A6980

# TECHNICAL INFORMATION

**Subject** ▶ Change of Spur gear 51 and Driving flange  
Elimination of Pin 6 and Flat washer 30

**For Models** ▶ BHR242, BHR243, DHR242, DHR243, HR2300, HR2310T, HR2600, HR2601, HR2610, HR2610T, HR2611F, HR2611FT, HR2621, LXRH01, LXRH02, XRH01, XRH02

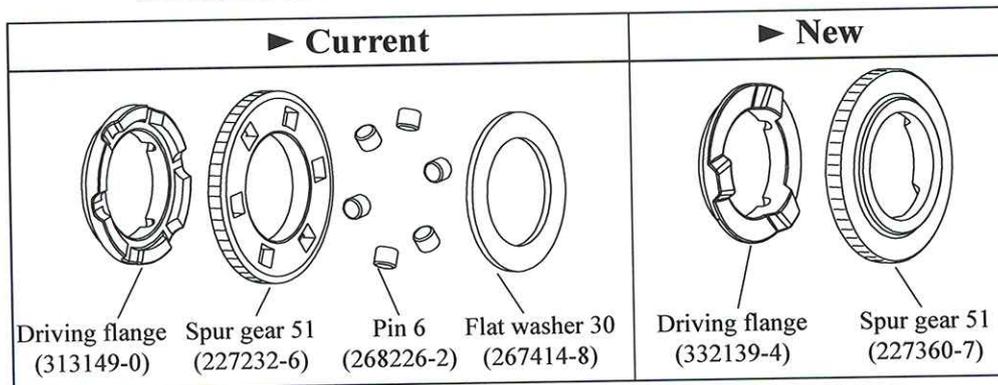
**Description** ▶ To improve the durability of Spur gear 51:  
• Spur gear 51 and Driving flange have been changed.  
• Pin 6 (6 pcs.) and Flat washer 30 have been eliminated.  
See below for the details.

Item No.	Current part	Q'ty	I/C	New part	Q'ty	Note
①	See below.	Spur gear 51 227232-6	1	No	Spur gear 51 227360-7	1	Interchangeable as a set
②		Driving flange 313149-0	1	No	Driving flange 332139-4	1	
③		Flat washer 30 267414-8	1				
④		Pin 6 268226-2	6
